City of Mississauga Department Comments

Date Finalized: 2021-10-27	File(s): A418.21 Ward 7
To: Committee of Adjustment	
From: Committee of Adjustment Coordinator	Meeting date:2021-11-04 12:00:00 AM

Property Address: 485 Chantenay Drive

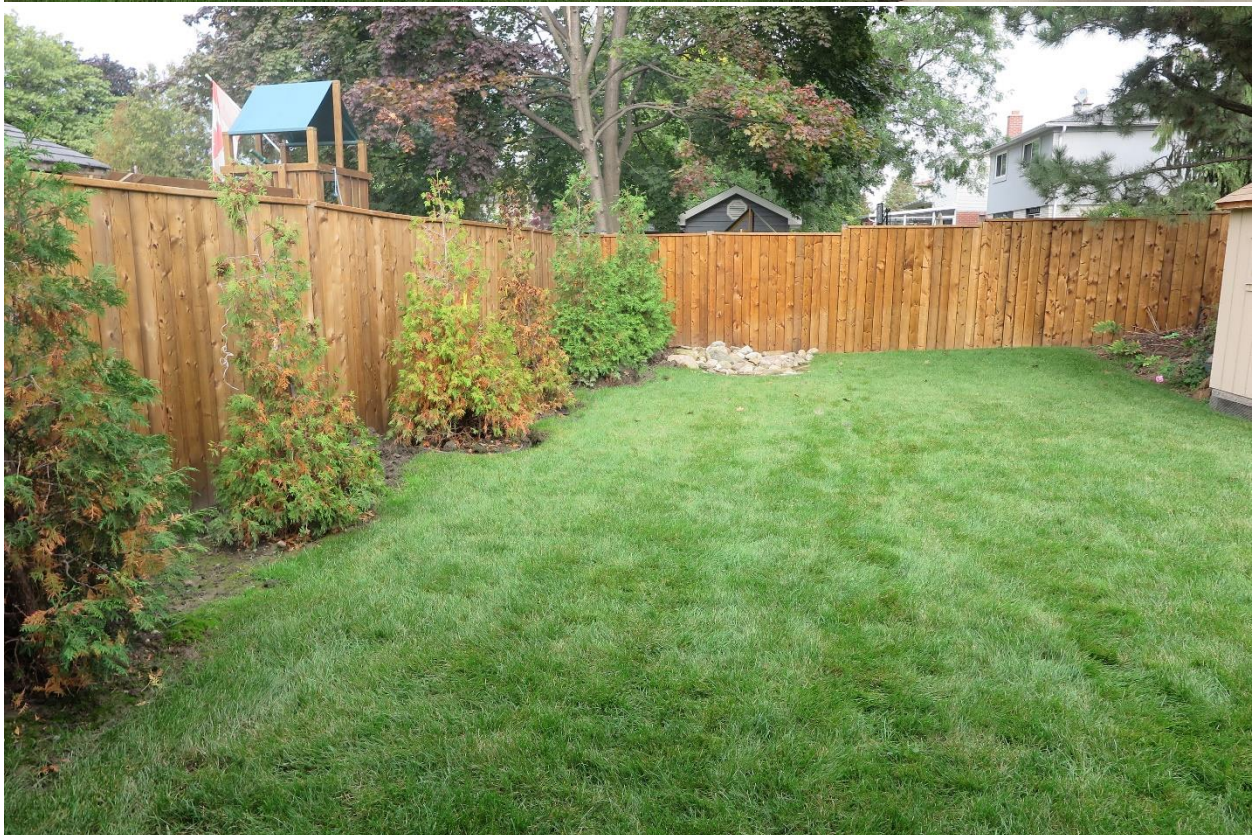
We have enclosed photos depicting the existing as constructed covered rear and side patio and also a photo of the existing catch basin in the rear yard. As depicted on the Site Plan submitted with the application, the existing covered patio has been constructed within the limits of an easement. We note that this is a city storm sewer easement. In accordance with City Plan and Profile Dwg C-08405 and Storm and Sanitary Sewer Plan Dwg C-08401 [both plans prepared by G.V. Kleinfeldt & Associates Ltd. and dated June 1966] there is an existing 3.05m (10.0ft) storm sewer easement which contains a 10 inch catchbasin lead extending into the rear yard where there is a catch basin. A review of the Grading Plan approved for this plan subdivision (Plan C-08403, dated June 1966) also indicates that the rear yards of the lots (approximately 4 lots) on the west side of Baynham Court were designed such that drainage from the rear yards was to be directed into the catch basin located on this property.

From our site inspection, and as evident in the photo provided, the existing catch basin has not been impeded and appears to be accommodating drainage from the lots to the north (lots fronting onto Baynham Court), however, it should be noted that we could only visually inspect what is visible from the rear yard of 485 Chantenay Drive.

With respect to the existing as constructed covered porch within the easement, this department **cannot support** a permanent encroachment into the existing City storm sewer easement. The storm sewer easement is there to protect the storm pipe for damage and to provide a free and unencumbered area should the sewer need replacing in the future. The easement language which is registered on title of the property prohibits buildings or structure within the storm sewer easement. All permanent structures such as the covered porch in the side and rear yard within the easement are to be removed from the easement and reinstated with appropriate landscaping as permitted within the easement. The current built covered porch structure make it impossible to maintain or replace the storm sewer should it fail in the future. Therefore, this department requests **refusal** of the side yard variance requests and eaves requests as it relates to the covered porch in the side and rear yard that encroach in to the storm sewer easement.
